LEGAL NOTICE EXETER PLANNING BOARD AGENDA

**RE: Application for Minor Site Plan Review
Response to Technical Review Comments
Phillips Exeter Academy – Love Gym Warm-Up Pool Addition
54 Court Street - Tax Map 81, Lot 01
Altus Project P5724**

PHILLIPS EXETER ACADEMY LOVE GYM WARM-UP POOL ADDITION

C.2

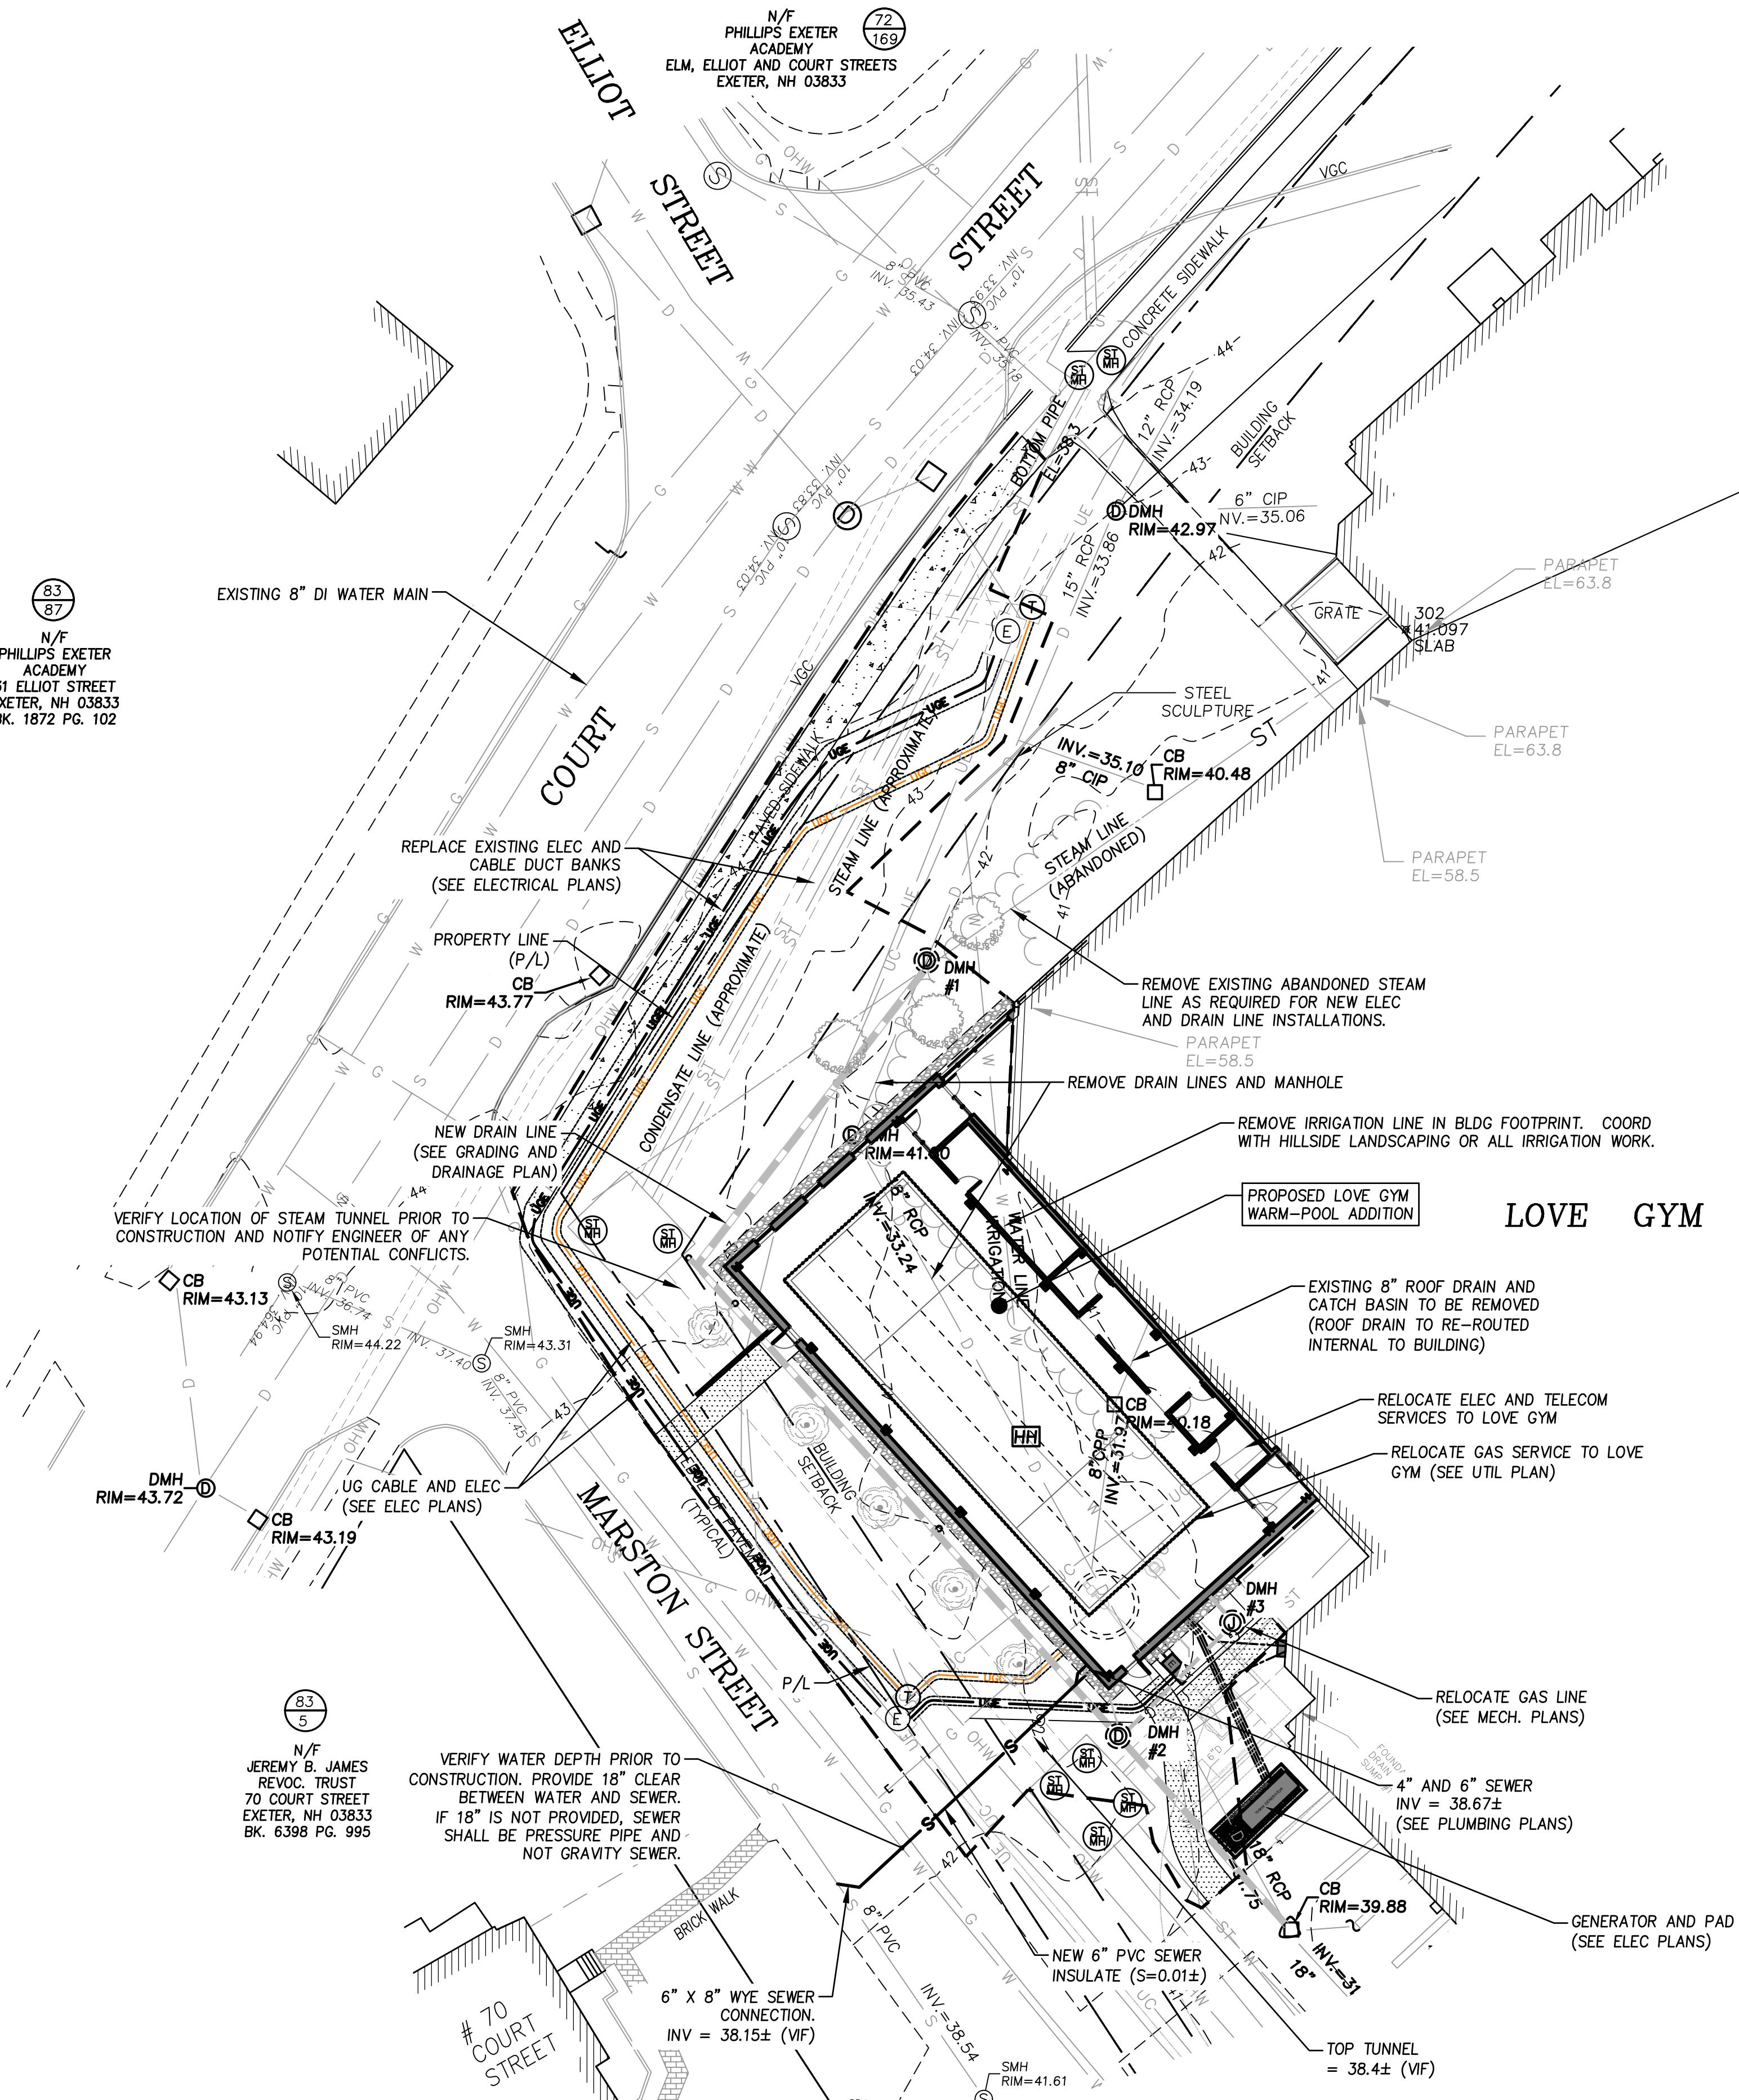
1. Add the following information to the plans:
 - a) Material and size of existing water mains in Martson Street and Court Street
 - b) Existing SMH inverts
 - c) If known, approximate depth of water main in Martson Street

2. DMH #2 is proposed directly on top of an existing steam line. We understand from discussion during the TRC meeting that the steam lines are likely be further to the west than is shown and the Contractor will likely shift the DMH a foot or two as needed during construction to avoid a conflict if necessary. Perhaps a note could be added to this effect to require verification of the steam line location, provide direction to shift DMH and/or coordinate with the design engineer in the field. Does the typical detail need any modifications for that location, i.e additional structural fill, geo grid, etc.? Can the turn be accommodated with a fitting rather than a structure at this location to minimize point load?

3. It is noted electrical and telecom lines are shown rerouted with almost zero clearance around the building corner and the DMH. Coordinate with comment 2 above.

- The new sewer service will cross over the existing water main. If 18" of clearance cannot be achieved, with two layers of insulation, pressure pipe shall be used. Provide direction to the Contractor through notes or a detail.

- If applicable, show the location of new utility pads such as a transformer.

Response: a) The 8" DI water main in Court st has been labeled. Altus does not have the size main in Marston Street. Note, there are no proposed connections to existing water as all water is internal to the building. b) Additional sewer inverts have been added. c) Altus does not have the depth of water main in Marston.

Response: DMH #2 has been replaced with a 90 bend and cleanout. The steram line location has been revised based on record data. Notes have been added to verify location of steam tunnel prior to construction and notify the engineer of any potential conflicts.

Response: The electrical and telecom lines have been revised and will go around the outside of the steam vault. The sidewalk in Court Street is shown to be replaced to concrete. See sheet C.2.

Response: A note has been added to the Utility plan, sheet C.2, to verify water elevation prior to construction and use pressure sewer pipe if 18" separation can not be achieved between water and sewer.

Response: New generator and pad location has been added to sheet C.2.

WATER MAIN / SEWER CROSSING

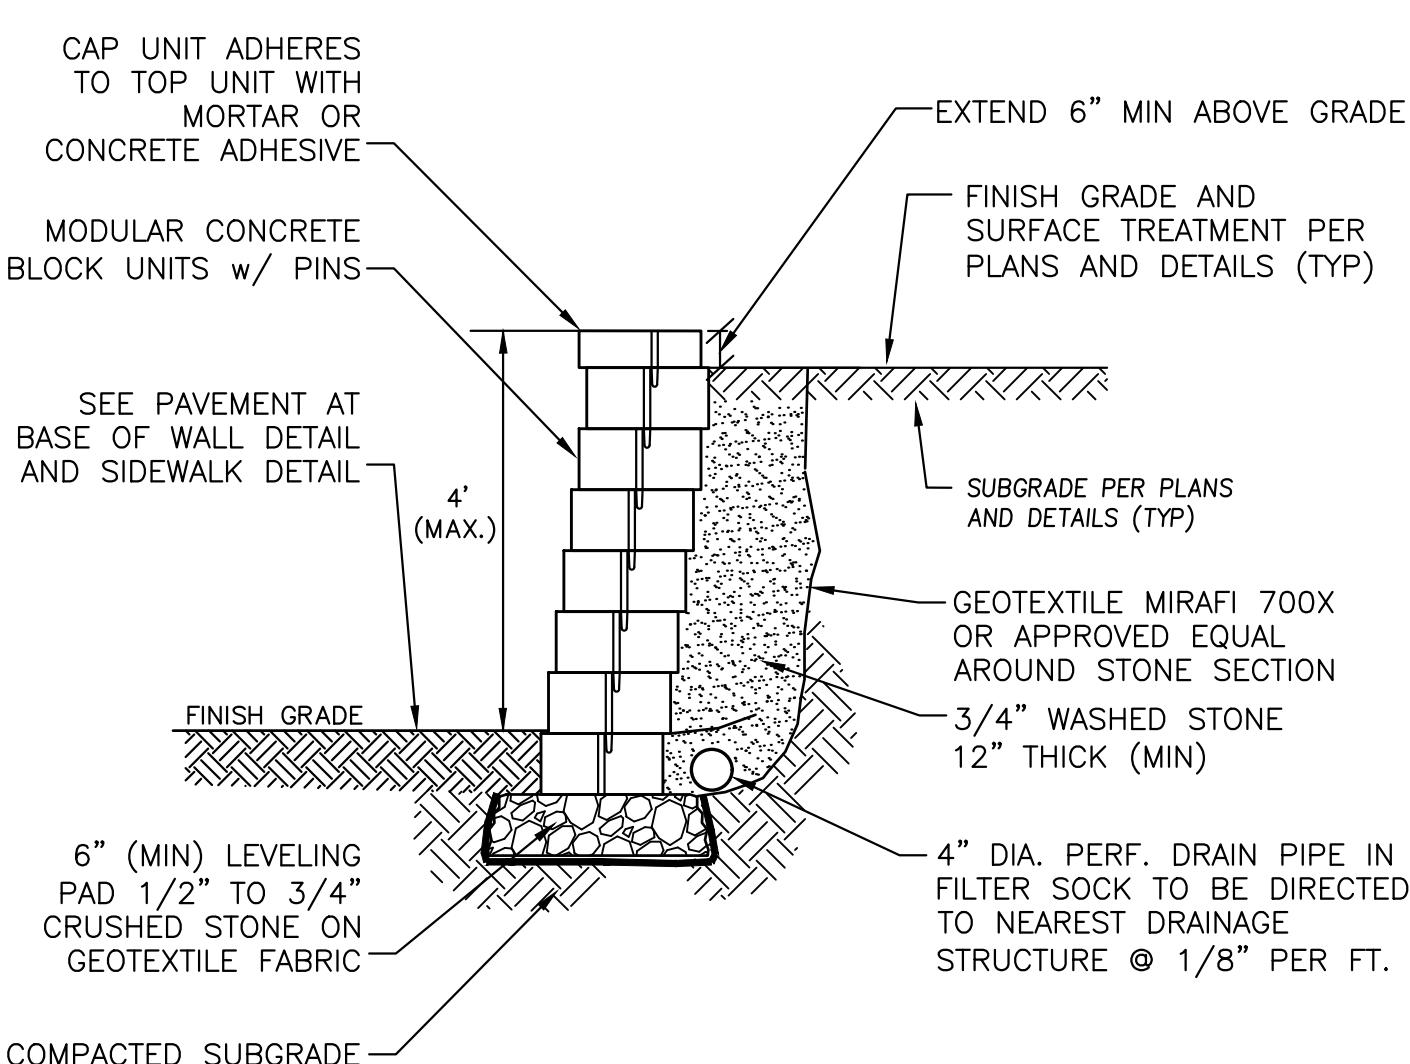
- Add the following details:

Response: The concrete washout and sewer /water crossing details have been added to sheet C.6.

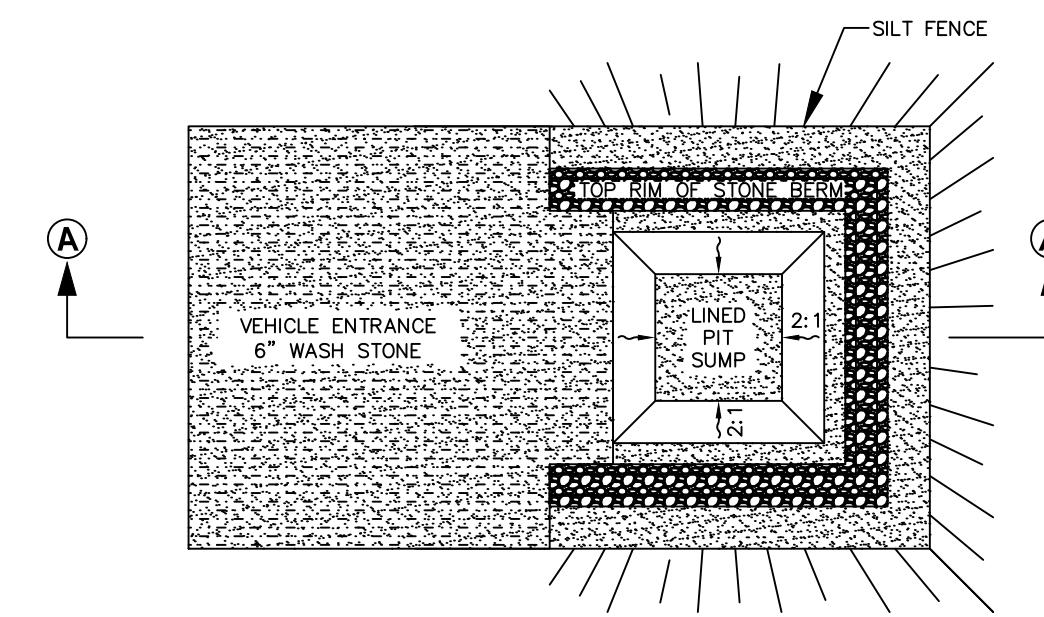
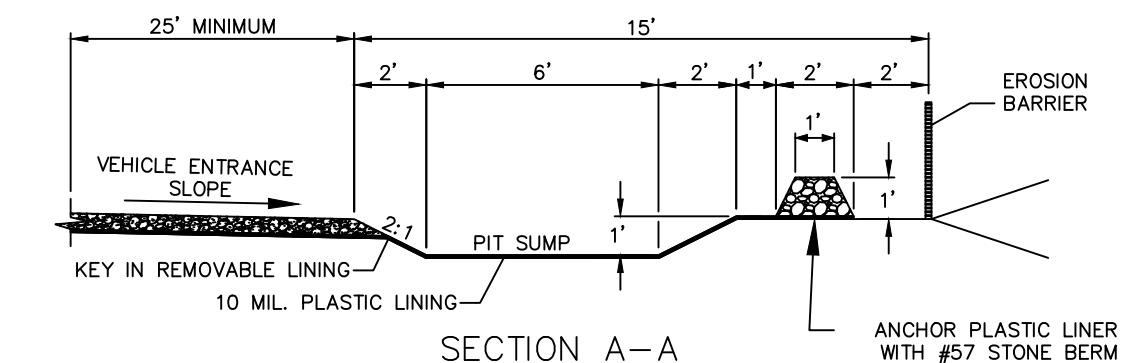
- Add a note directing the Contractor to install a concrete washout pit prior to any concrete pours.

Response: The note has been added to the grading plan, Sheet C.3 and the detail added to C.6.

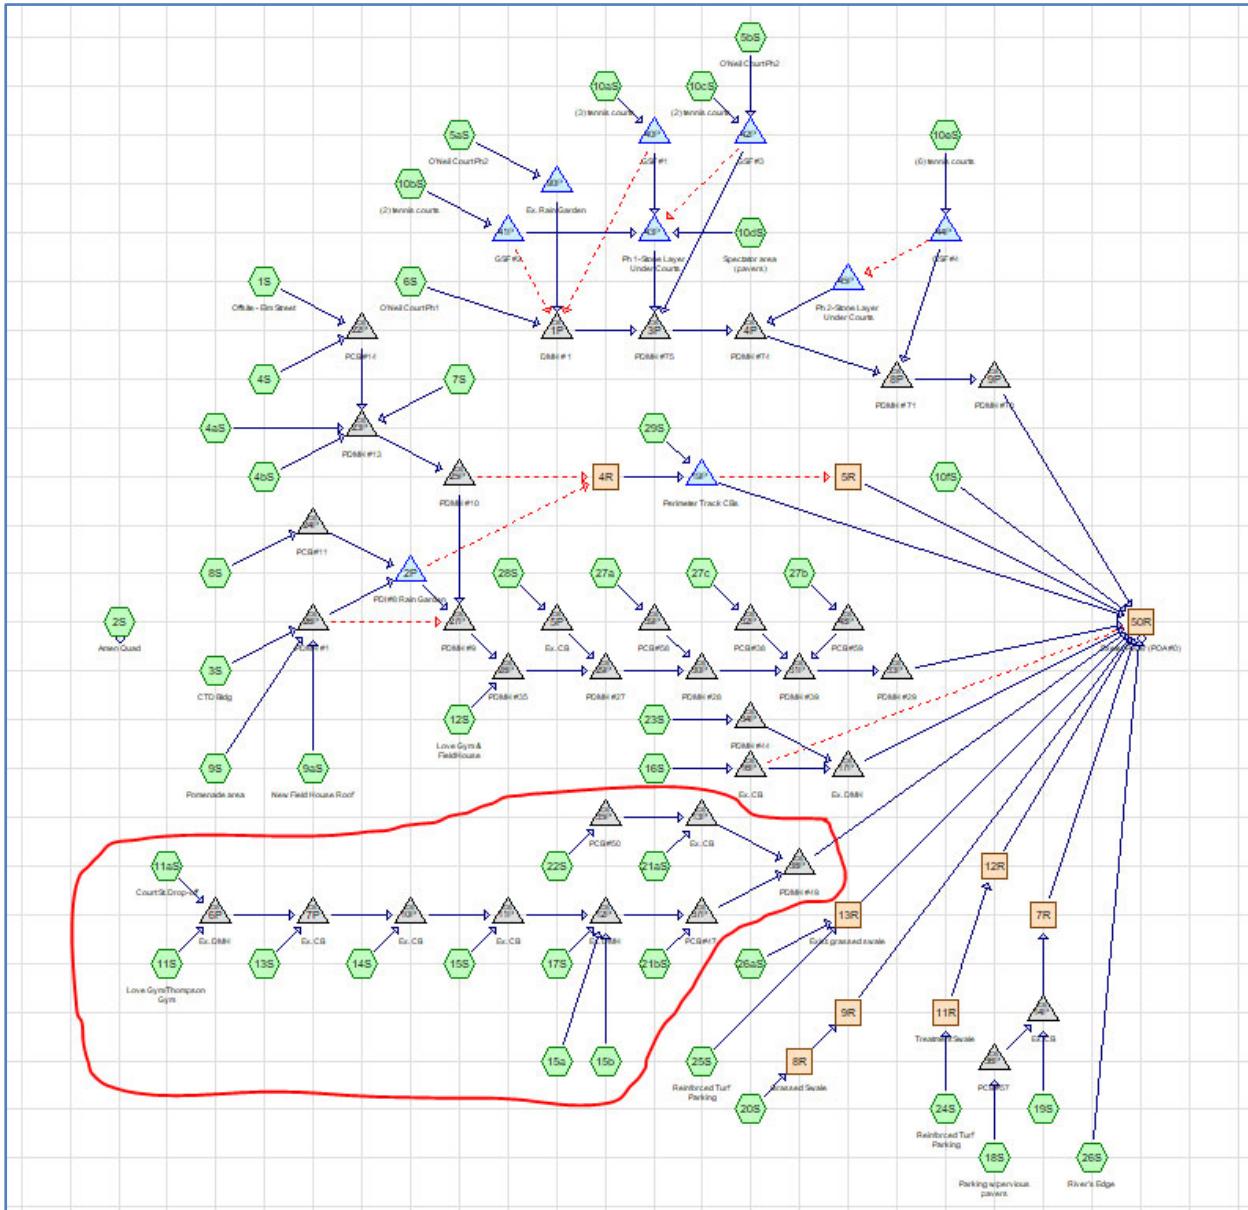
2. The addition is clearly within subcatchment 13 per the post-development drainage plan, however the narrative and drainage model directs it through subcatchment 11. UE presumes that is related to plan notations regarding rerouting roof drains internal to the building. Please Confirm. If that is the case, the post-development drainage figure should label the addition as supplement to subcatchment 11 for clarity.

Response: Correct. Altus has revised the model to create a new subcatchment 13B for the Warm Up Pool only. The new building is within watershed 13, so the grass area from watershed 13 has been replaced with a new watershed 13B and 500 sf of paved area added for the walkways. As mentioned above, this watershed will pass through a jellyfish filter tank for pollutant removals, prior to connecting back into the existing closed drainage system. The results continue to indicate negligible impacts to the overall site drainage discharges flows.
